# SERVICE BULLETIN

No. 420

Piper Aircraft Corporation

Subject: Inspection of Heated Windshield

Heated Windshields - Exterior View

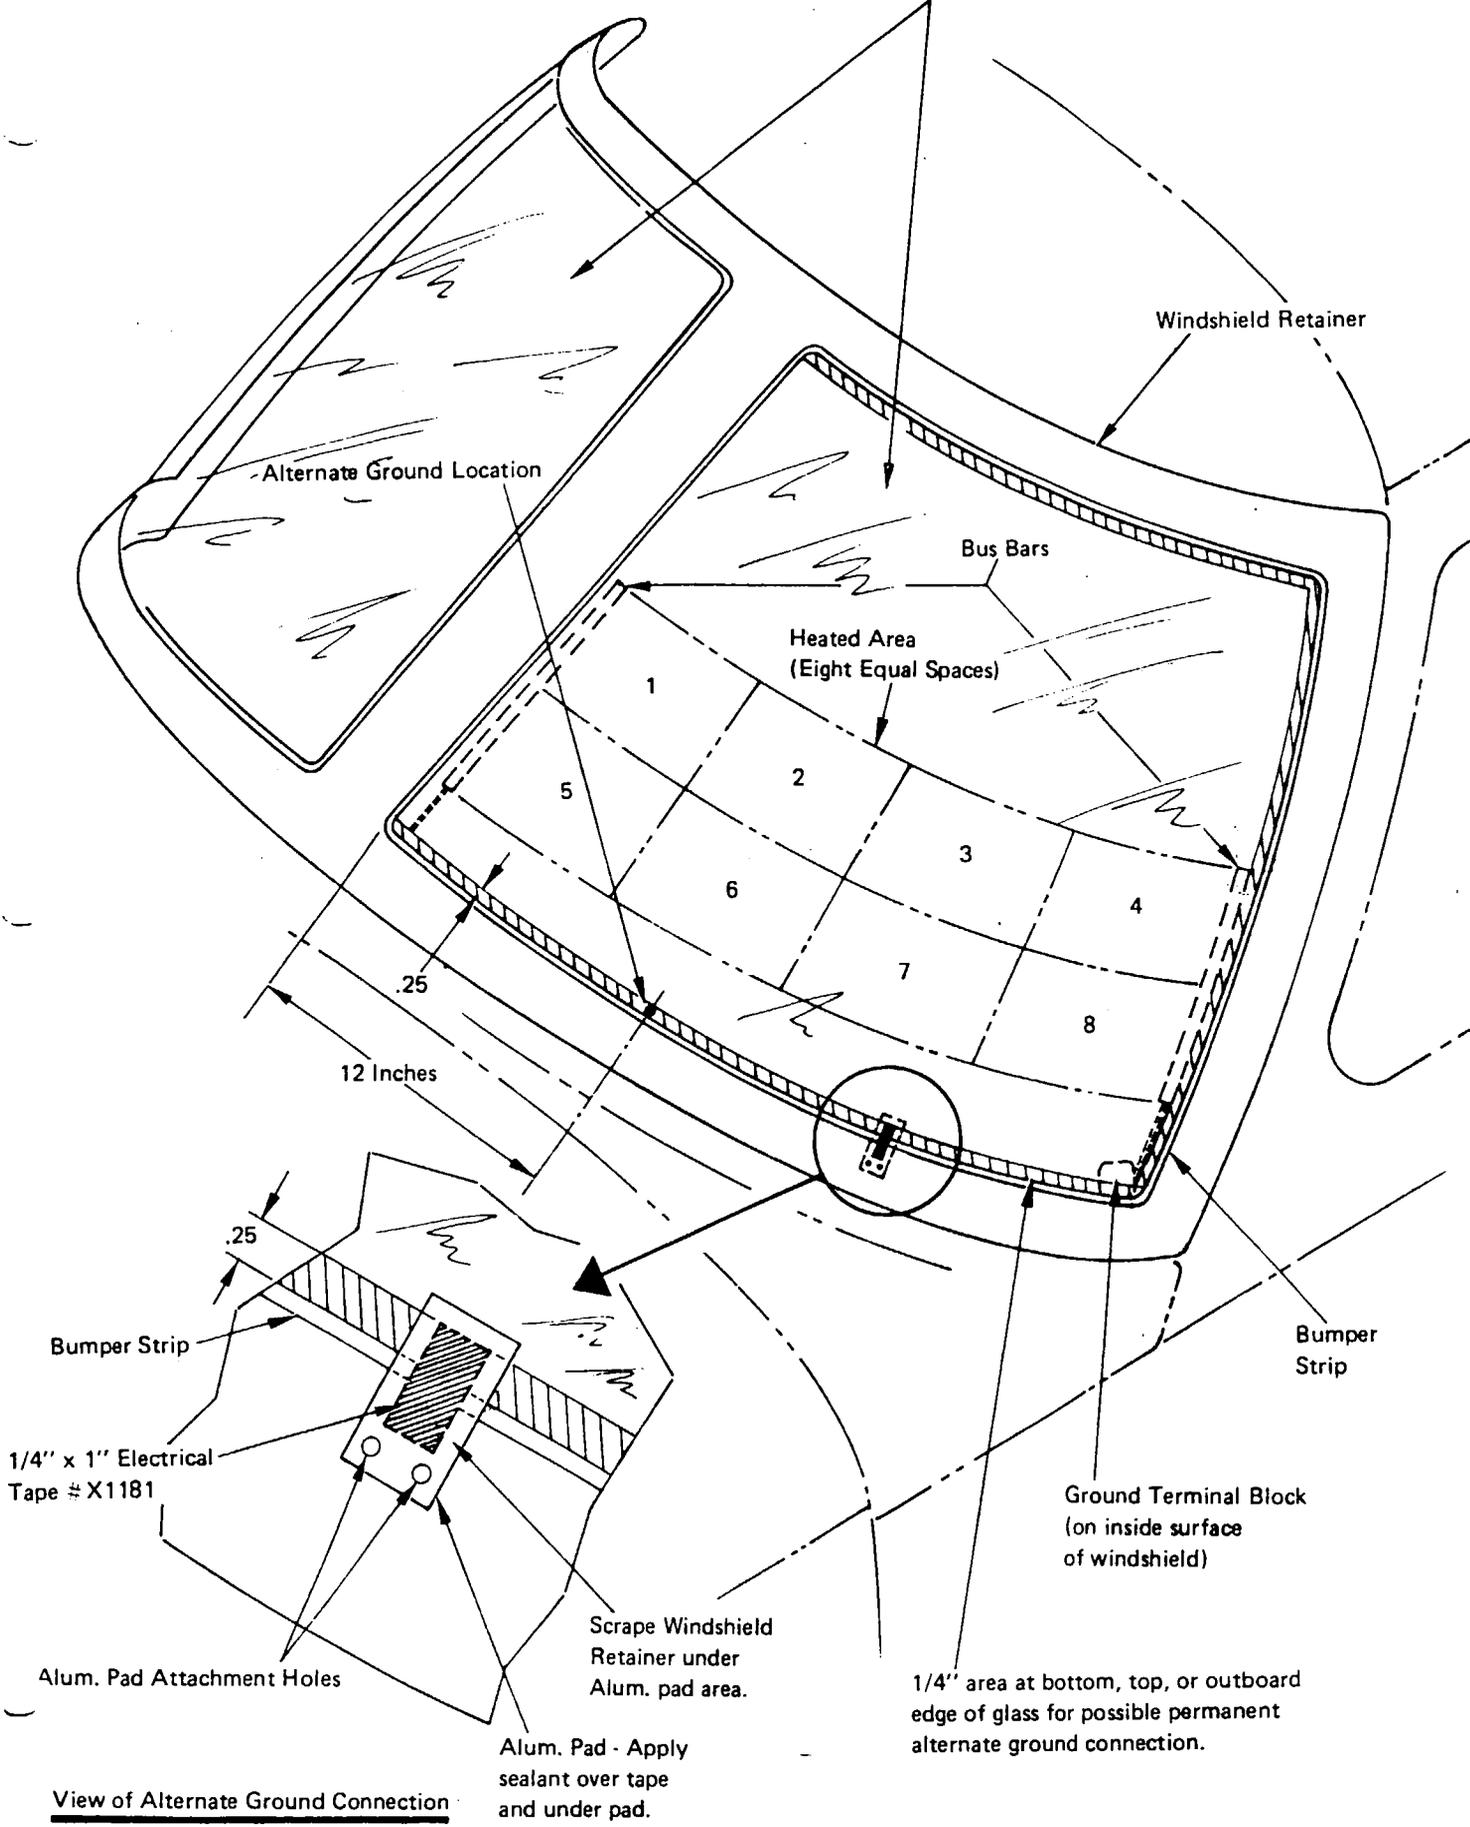
1. Clean the windshield to remove dust and dirt.
2. Using approximately 1/2" wide masking tape, define the windshield heated area into eight approximately equal sized areas. (See sketch.)
3. Using an ultra high sensitivity volt-ohm micro ammeter such as a Simpson 269, set the range dial to 100 K. Next, zero the meter reading. Then connect the alligator clip of one of the test leads to the windshield ground power terminal (or APU ground connection on PA-31P). Connect the alligator clip of the other test lead to the pure copper puff supplied in kit.

4. Contact the windshield surface within each of the eight areas with the copper puff surface. If six or more of the eight areas indicate a meter reading of 100,000,000 ohms (reads "1K" on the Simpson 269) or less, the windshield is completely acceptable for anti-static protection, and no further action is necessary.

5. If three or more of the areas do not indicate a reading of 100,000,000 ohms or less, move the puff around thoroughly within the suspect area to determine if the acceptable reading can be found anywhere within the area. If a reading of 100,000,000 ohms or less can be found within a suspect area, using this procedure, then this area is acceptable. This procedure should be repeated for each suspect area. The final tally should show six or more of the eight areas to be acceptable in order for the windshield to be completely acceptable for anti-static coating protection, thus requiring no further action.

6. If three or more of these eight areas do not meet the requirement, there may be a faulty connection to ground. It is then recommended the following additional check procedure be used:

Disconnect the alligator clip from the ground terminal (or APU ground), and use it to contact the outer glass surface within 1/4" of the lower edge of the glass, approximately 12 inches from the centerpost. (See sketch.) With the other contact that is still connected to the copper puff, repeat the eight area check procedure defined in Step 4. If three or more of the eight areas are not acceptable, proceed to Step 9. If six or more of the eight areas are acceptable, a new ground connection can now be made as follows:

7. For future reference, place a mark on the retainer collar, adjacent to the contact point at the lower glass edge. Scrape the paint and primer from the retainer collar at this marked position, to expose the bare metal in an area 1/4" x 1/4". (See sketch.) Apply a 1" long x 1/4" wide strip of Scotch electrical tape #X1181 (supplied with kit), 1/4" onto the glass surface and extending back across the bumper strip onto the scraped retainer collar area. The new ground connection has been made.

8. The Scotch electrical tape must be permanently protected from weathering as follows: Using the sandblasted aluminum pad (supplied with kit) locate the hole positions on the retainer collar that would completely cover the X1181 tape. Next, drill and tap the two holes in the retainer. Using RTV 106 or PR 1422 soft weather sealant, pot the pad on over the tape. Then permanently connect the pad to the retainer collar with the screws supplied with kit. The new permanent ground connection is now complete.

9. If upon completion of the eight area survey of Step 6 three or more areas are not acceptable, an alternate ground location may still be available. Move the alligator clip, without copper puff, along the bottom glass edge to various positions and conduct the eight area survey of Step 4. If still three or more of the eight areas are unacceptable, continue the survey by probing along the outboard glass edge and the top glass edge while surveying the eight areas. If an acceptable location for an alternate ground tab is found, Steps 7 and 8 should be followed. If no satisfactory alternate location is found, you should contact the windshield vendor PPG Industries to discuss your survey and determine if windshield should be removed and replaced. Contact Bill Heidish at PPG, 205-539-8121.
